Subject: REAR DOOR WILL NOT OPEN	Bulletin No: 09-023/13
	Last Issued: 08/13/2013

2014 Mazda6 vehicles with VINs lower than JM1 GJ ***** 119979 (produced before April 9, 2013)

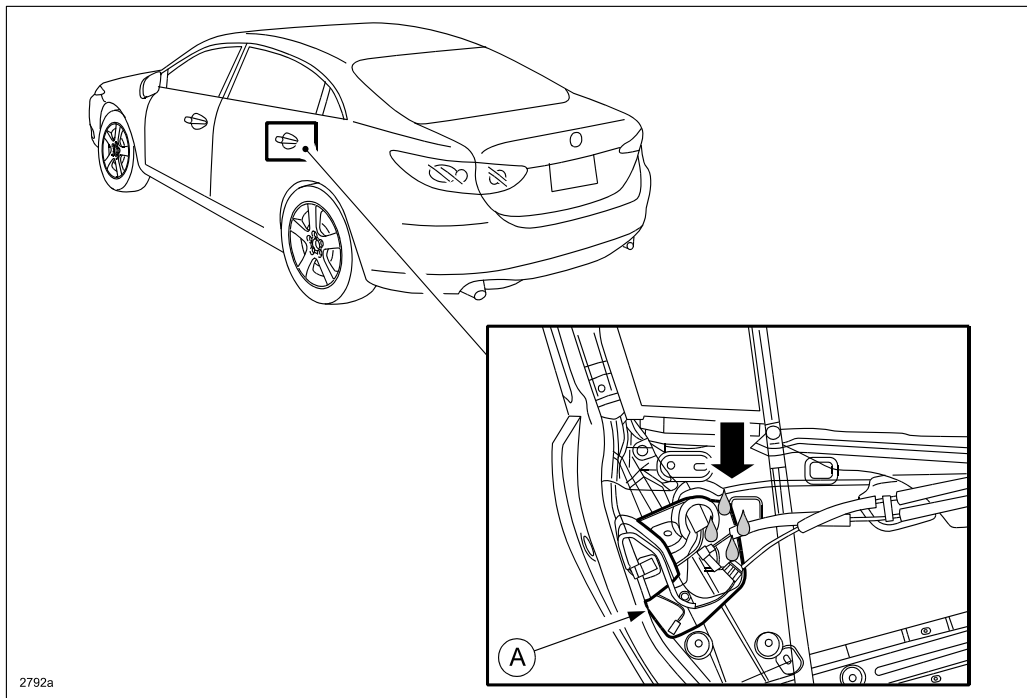
When the ambient temperature drops below 32 degrees Fahrenheit (0 degrees Celsius), especially after rain or car wash, some customers may experience a rear door(s) that will not open. This may be caused by water entering the inside of the rear door latch and lock actuator (A) and then freezing at low temperatures.

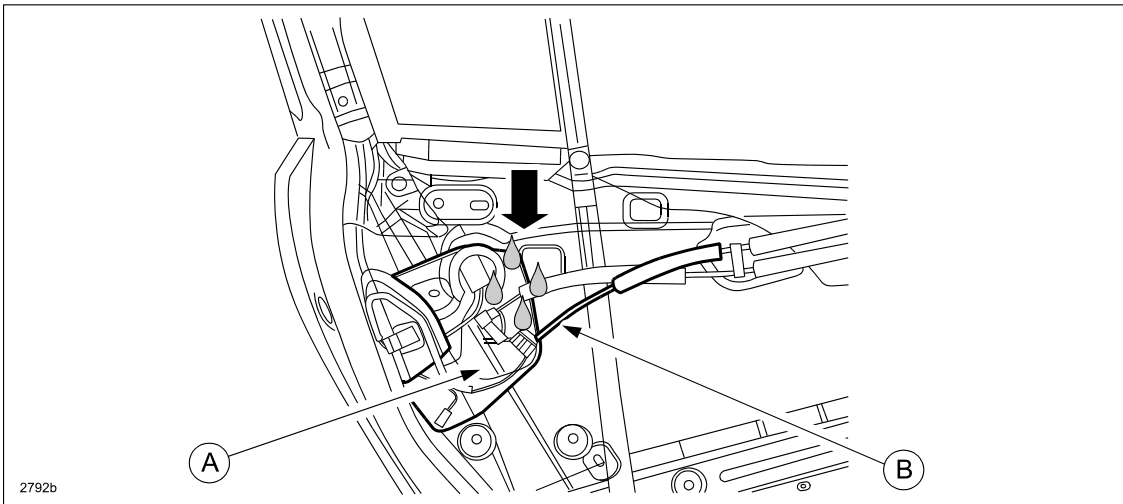
1. Verify customer concern.
2. Remove the rear door trim. Refer to MS3 online or Workshop Manual (section 09-17 REAR DOOR TRIM REMOVAL/INSTALLATION).
3. Remove service hole cover No.1. Refer to MS3 online or Workshop Manual (section 09-14 REAR DOOR LATCH AND LOCK ACTUATOR REMOVAL/INSTALLATION).
4. If wet, dry the rear door latch and lock actuator (A) and/or the door lock knob cable (B) using compressed air.

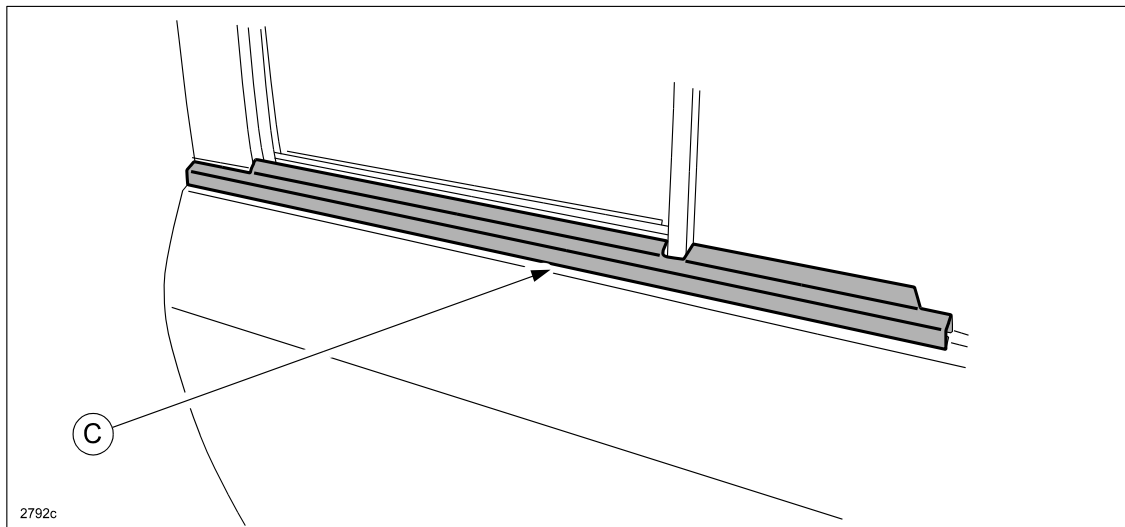
5. Replace the rear beltline molding (C). Refer to MS3 online or Workshop Manual (section 09-16 REAR BELTLINE MOLDING REMOVAL/INSTALLATION).

Part Number	Description	Qty.	Notes
GHK1-50-660C	Rear beltline molding	1	Right side
GHK1-50-670C	Rear beltline molding	1	Left side
